VEHICLE RECALL

AMERICAN TRANSPORTATION RECALL # 01303
NHTSA RECALL # 01V-269

SUBJECT: VEHICLE RECALL
Flip Seat Support Binding

Dear American Transportation Bus Customer:
Issue: Flip Seat Support Binding

Picture Showing Cushion Frame Support Bar Ready to Slip Off Seat Support Tab

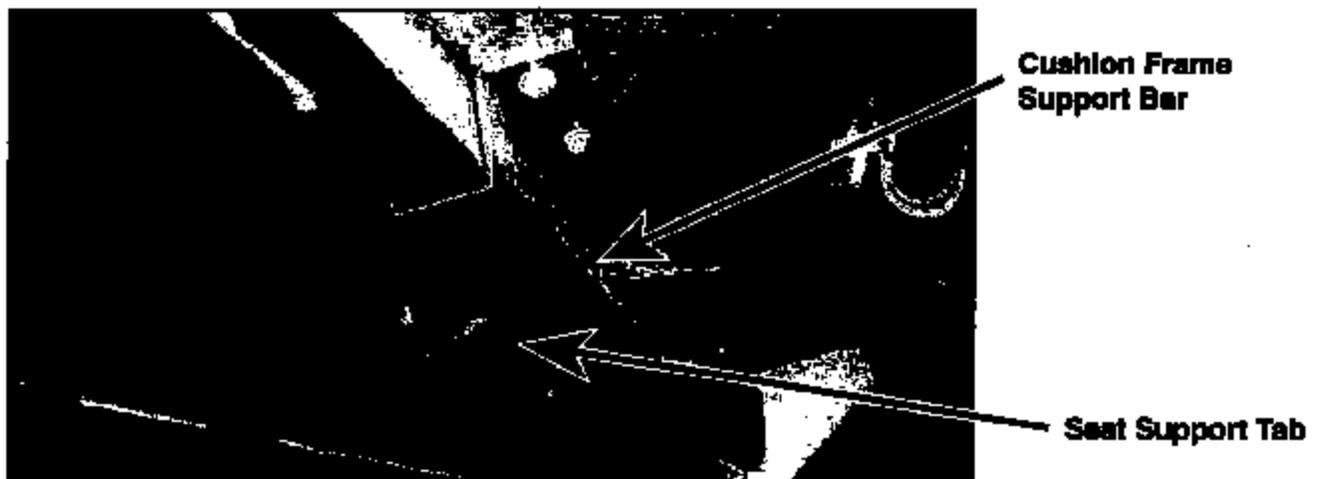
The cushion frame support bar slides off the seat support pad. When this occurs, the tabs can wedge against the support bar, which may retain the seat in the occupied position.

The repair procedure involves adding a "Z" shaped bracket to the underside of the seat. The following steps must be followed to repair the defect. (**WARNING: PROPER EYE PROTECTION MUST BE WORN WHILE OPERATING POWER TOOLS.**)

- Remove the existing seat retaining clip.
- The "Z" shaped bracket must be attached to the "Cushion Frame Support Bar" and the bottom side of the seat. The short leg of the bracket must face the rear of the seat. The bracket must be centered width wise on the "Cushion Frame Support Bar". The front edge of the bracket should align with the front face of the "Cushion Frame Support Bar". Make sure that the bracket will contact both "Seat Support Tabs".
- Using the holes provided in the bracket as a location guide, use a # 18 (0.1770) drill bit to drill three holes in the "Cushion Frame Support Bar" and three holes in the seat cushion plywood base. (Caution Do not drill completely through the plywood.)
- Install the supplied screws in all six holes.
- Complete and return the self addressed "RECALL REPAIR REPLY CARD" included with the kit.

PICTURE SHOWING REPAIRED SEAT WITH "Z" BRACKET

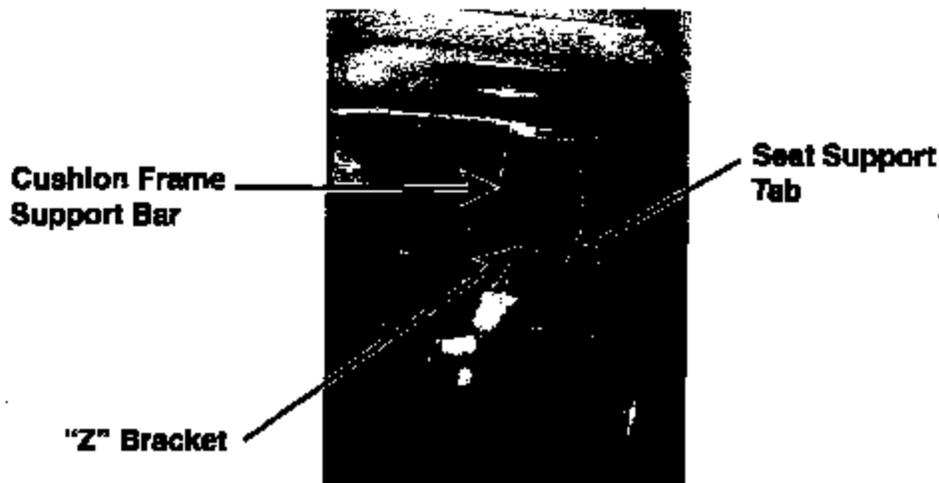
The cushion frame support bar slides off the seat support pad. When this occurs, the tabs can wedge against the support bar, which may retain the seat in the occupied position.

The repair procedure involves adding a "Z" shaped bracket to the underside of the seat. The following steps must be followed to repair the defect. (**WARNING: PROPER EYE PROTECTION MUST BE WORN WHILE OPERATING POWER TOOLS.**)

- Remove the existing seat retaining clip.
- The "Z" shaped bracket must be attached to the "Cushion Frame Support Bar" and the bottom side of the seat. The short leg of the bracket must face the rear of the seat. The bracket must be centered width wise on the "Cushion Frame Support Bar". The front edge of the bracket must be located 1/8 inch to the rear of the front face of the "Cushion Frame Support Bar". Make sure that the bracket will contact both "Seat Support Tabs".
- Using the holes provided in the bracket as a location guide, use a # 16 (0.1770) drill bit to drill three holes in the "Cushion Frame Support Bar" and three holes in the seat cushion plywood base. (Caution - Do not drill completely through the plywood.)
- Install the supplied screws in all six holes.
- Complete and return the self addressed "RECALL REPAIR REPLY CARD" included with the kit.
